Planning and Building Department

Geotechnical Consultant Approval

Subject: Highland Estates Lots 5-11 Response to County Comments

Date: September 21, 2018
Project No.: 230-1-6
Prepared For: Mr. Jack and Noel Chamberlain
TICONDEROGA PARTNERS, LLC
655 Skyway, Suite 230
San Carlos, California 94070
Re: Response to County of San Mateo
Planning Comments Dated September 5, 2018 on Lots 5 to 11
San Mateo Highlands
San Mateo, California

Sheet Number: **C11.30**
OF

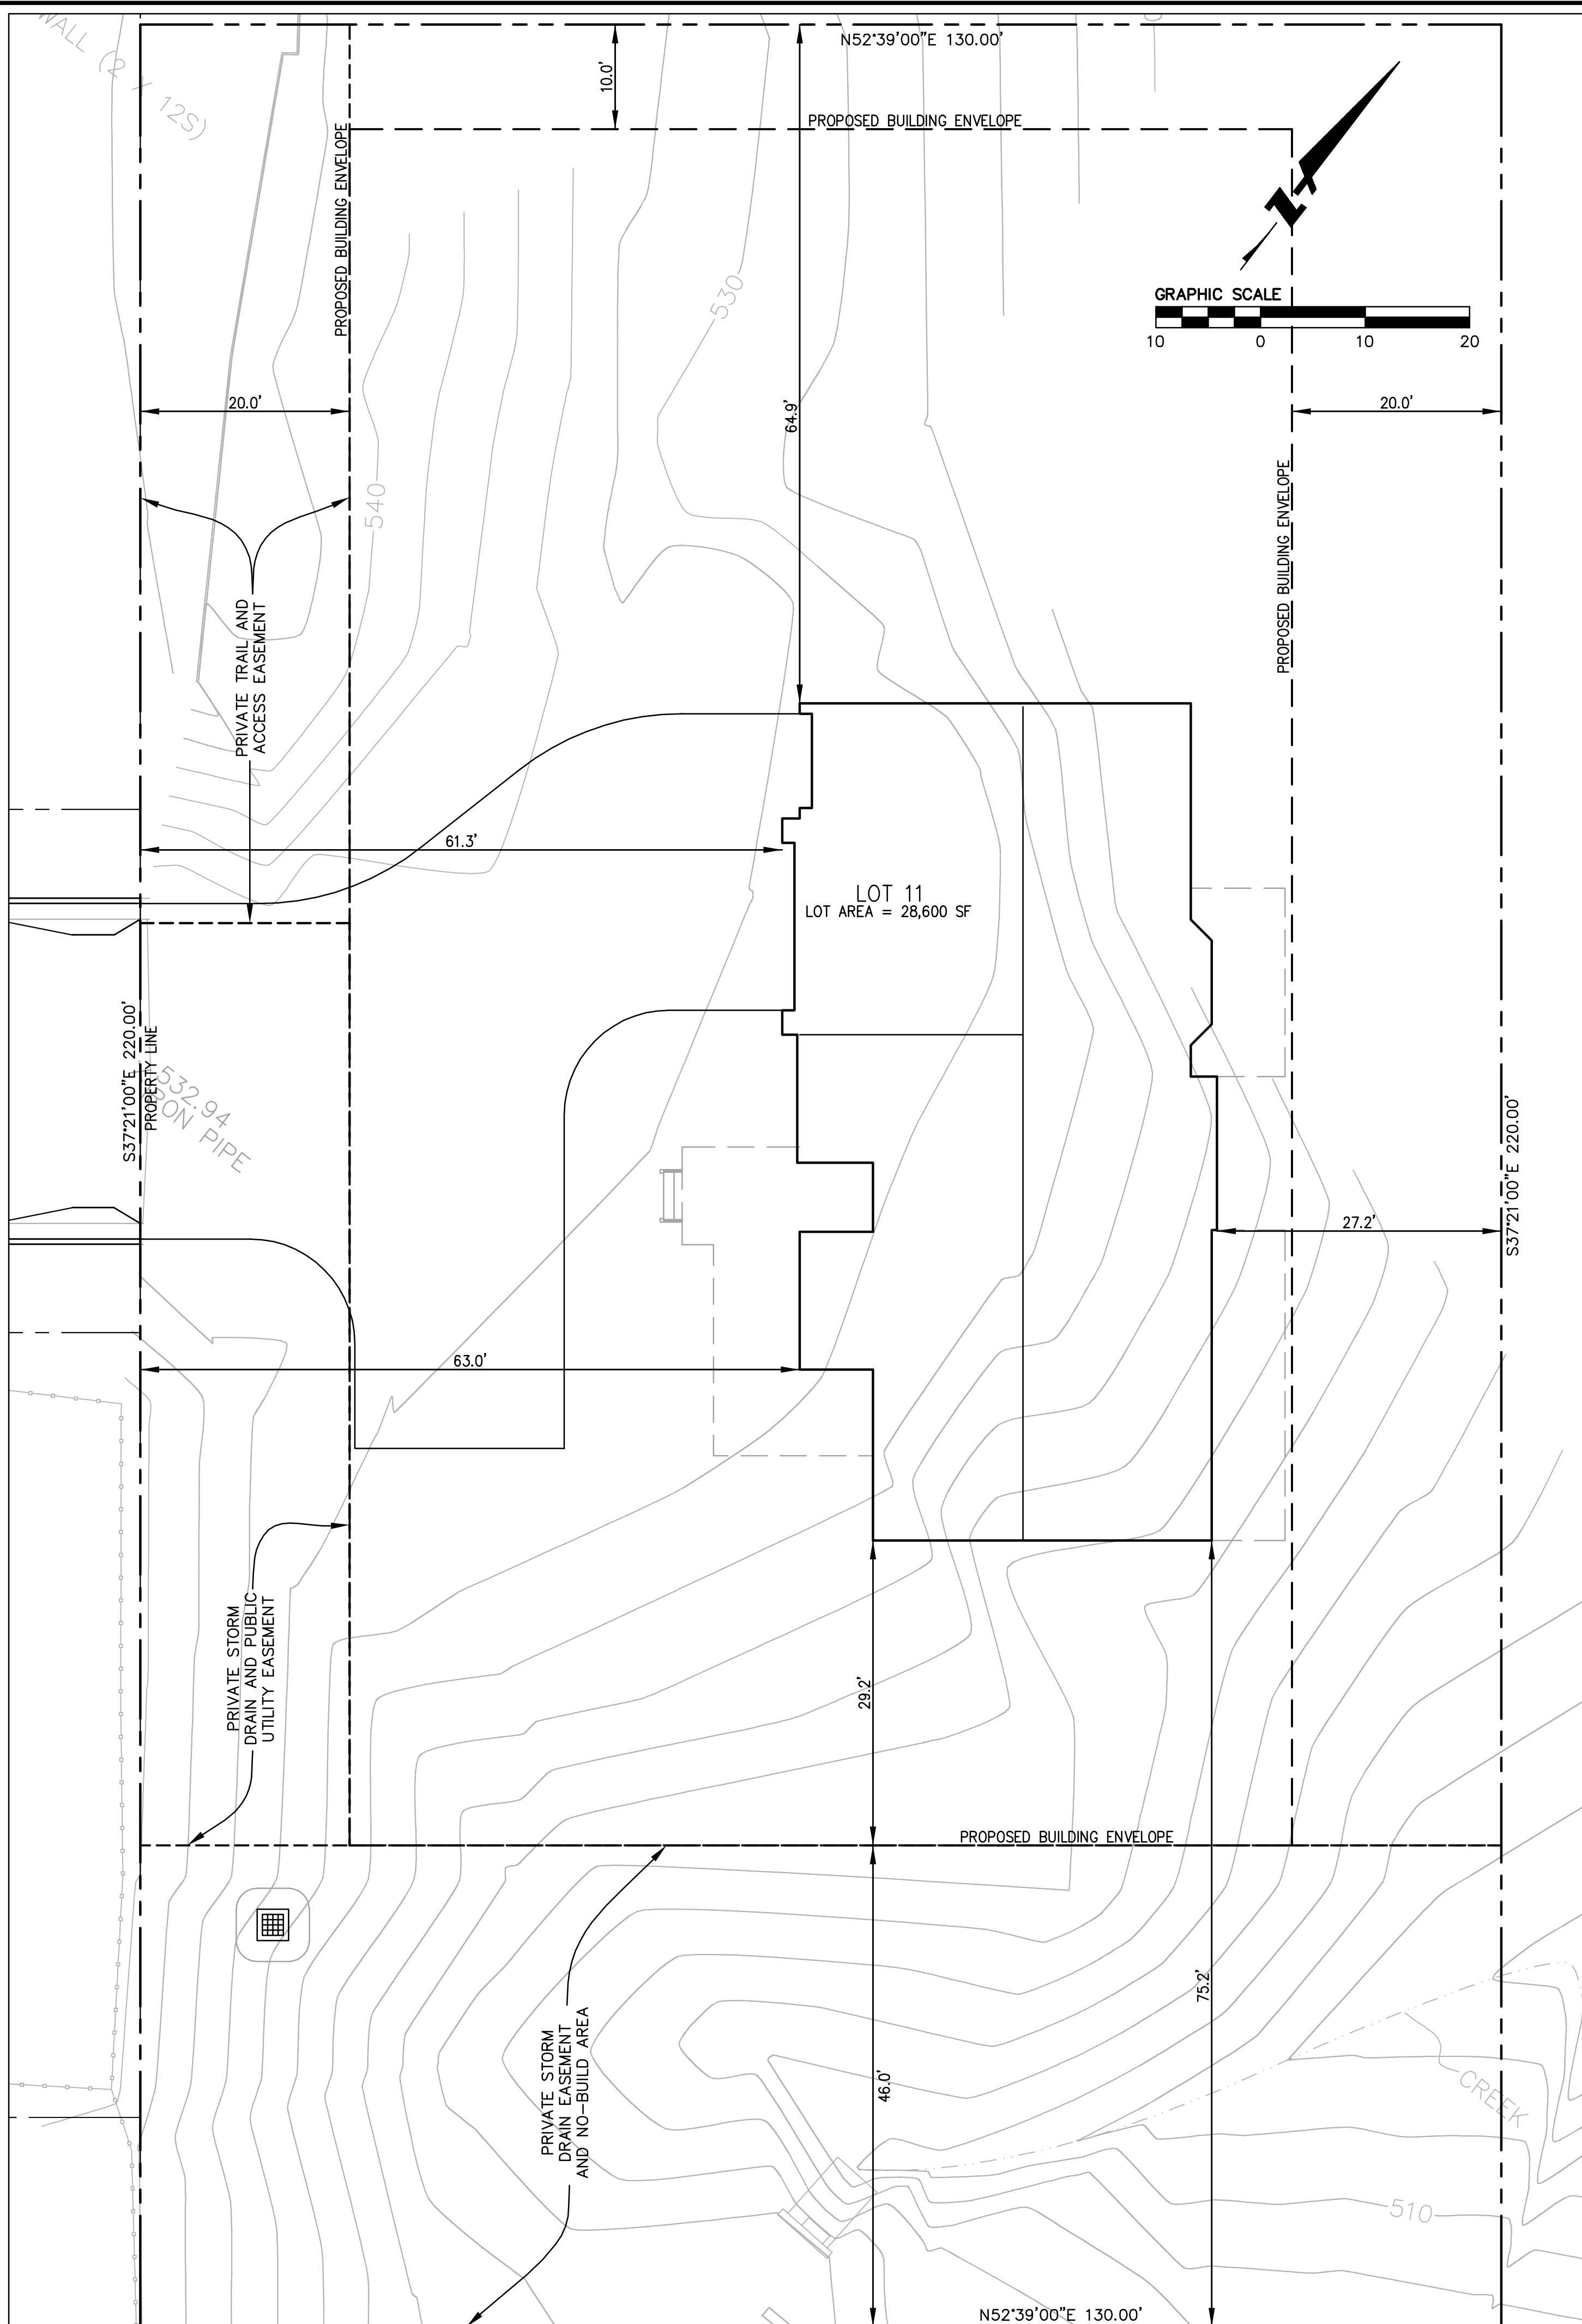
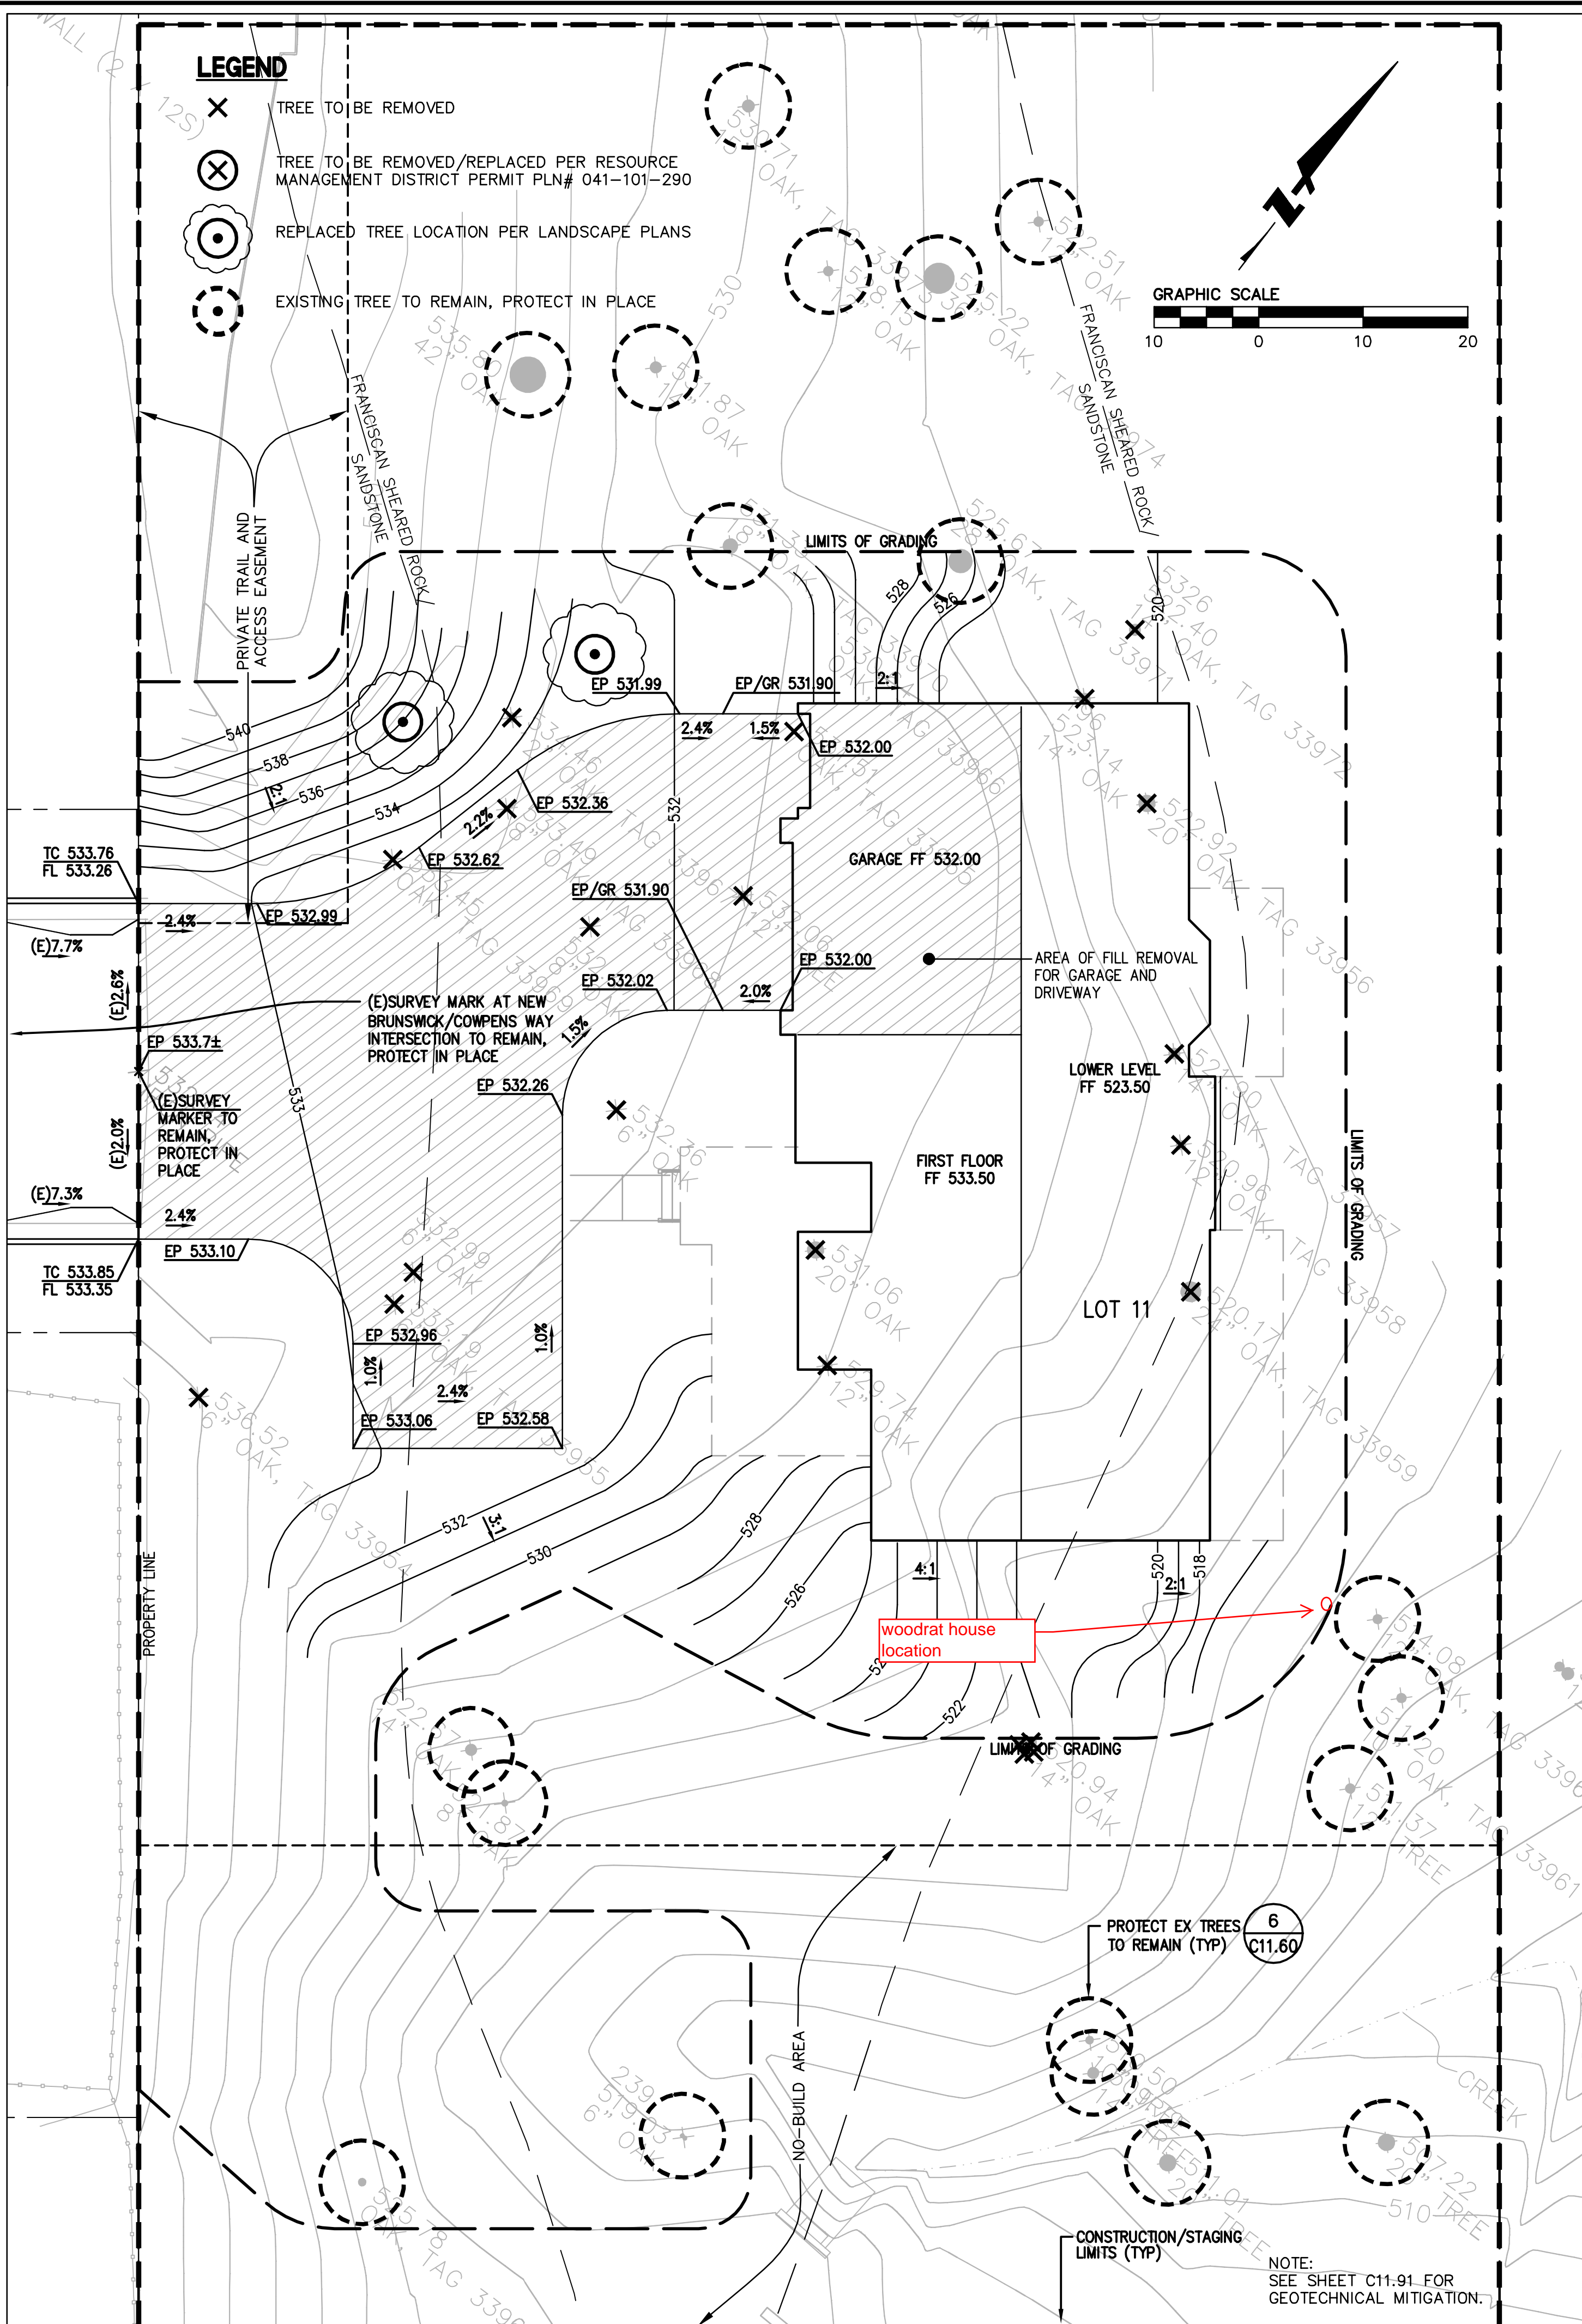
2. *In the Civil Plans, please show that the riprap for the outfall will be keyed into the bedrock, as stated in the Geo letter of 8/10/2018. Please show the location of sandstone (an alternative to bedrock) in plan-view relative to location of outfall.*

Response: Please see revised sheets C11.40 and C11.71 for outlet rock riprap keyed into the sandstone. Please also see revised sheets C11.30 and C11.40 for approximate location of sandstone in plan-view relative to the location of outfall.
